Cotton Farms  
 Lot 34  
 Riley C  
 Garage Left  
 Screen porch option

FRONT ELEVATION "C"  
 SCALE: ..... 1/4" = 1'-0"

**RILEY**  
 PLAN NAME  
 A-1977-54GL  
 PLAN I.D.  
 8-12-21  
 DATE

**A-1C**  
 SHEET

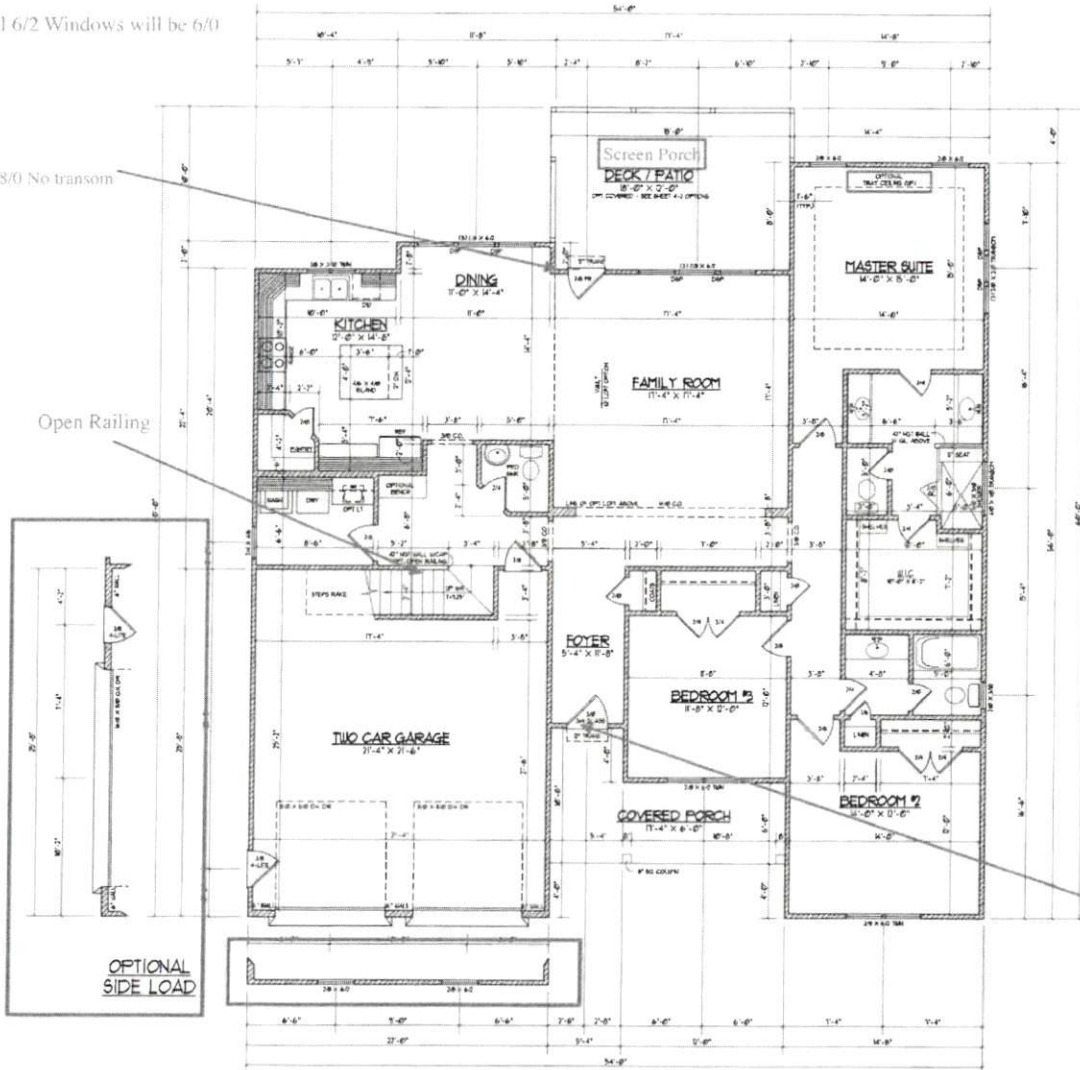
Zero Entry Shower

Painted Brick instead of stone

ELEVATIONS "A" & "C"  
FIRST FLOOR PLAN  
WITH SECOND FLOOR  
SCALE: 1/4" = 1'-0"

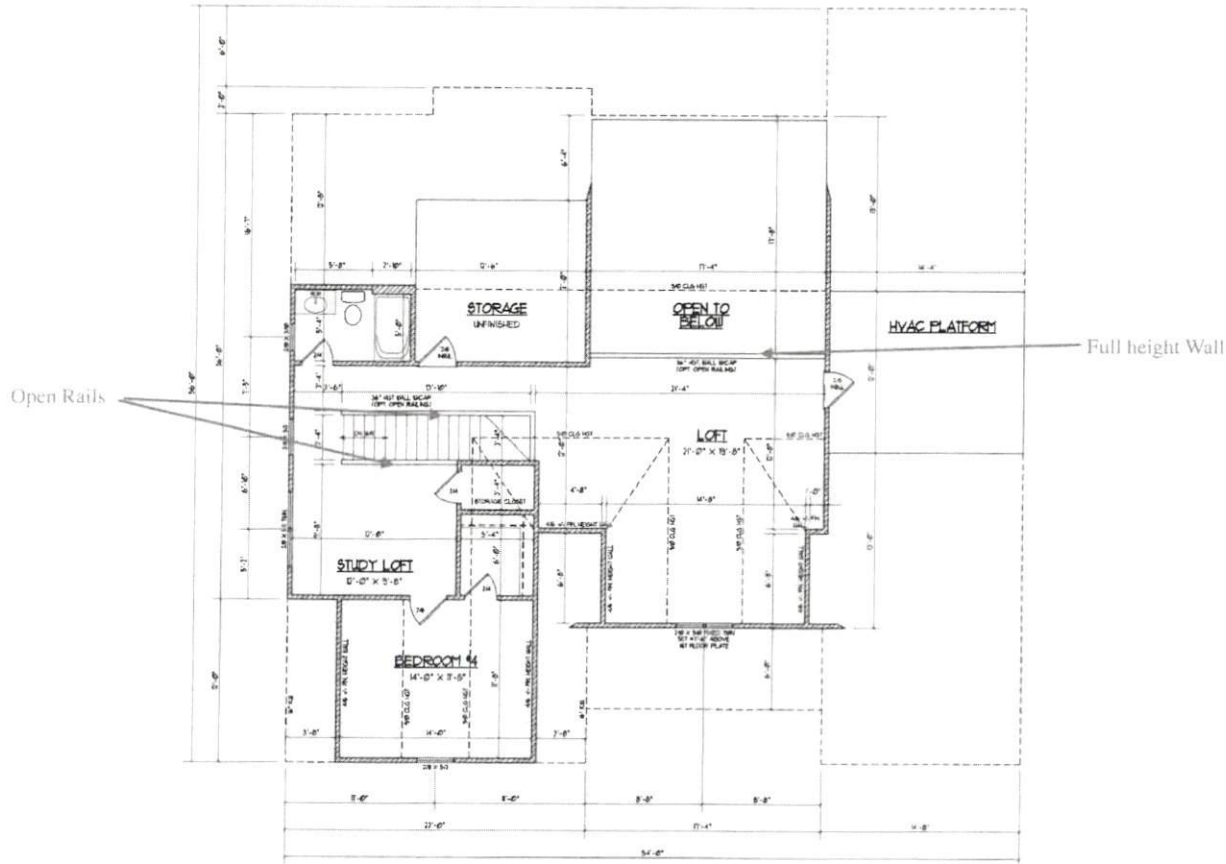
All 6/2 Windows will be 6/0

2/8 x 8/0 No transom

Open Railing

Zero Entry Shower

**ELEVATION "C"  
 SECOND FLOOR PLAN  
 WITH OPT. BEDROOM #4 / LOFT  
 & OPEN TO FAMILY ROOM**

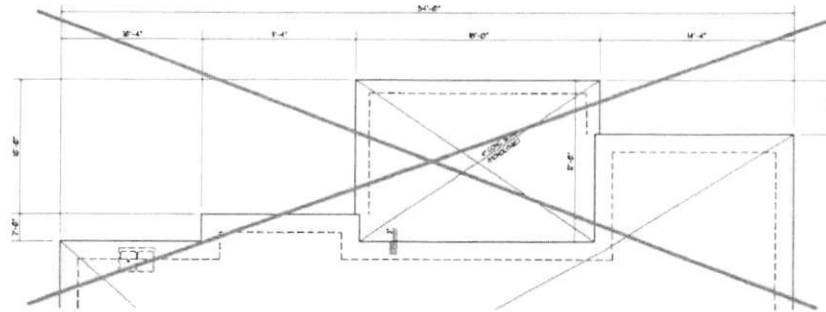
All 5/2 Windows will be 5/0

**ELEVATION "C"**  
**FIRST FLOOR CEILING /**  
**STRUCTURAL PLAN**  
**WITH OPT. BEDROOM #4 / LOFT**  
**OPEN TO FAMILY ROOM**  
 SCALE: 1/4" = 1'-0"

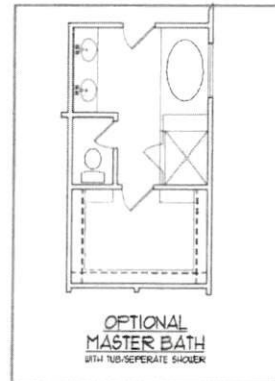
Zero Entry Shower
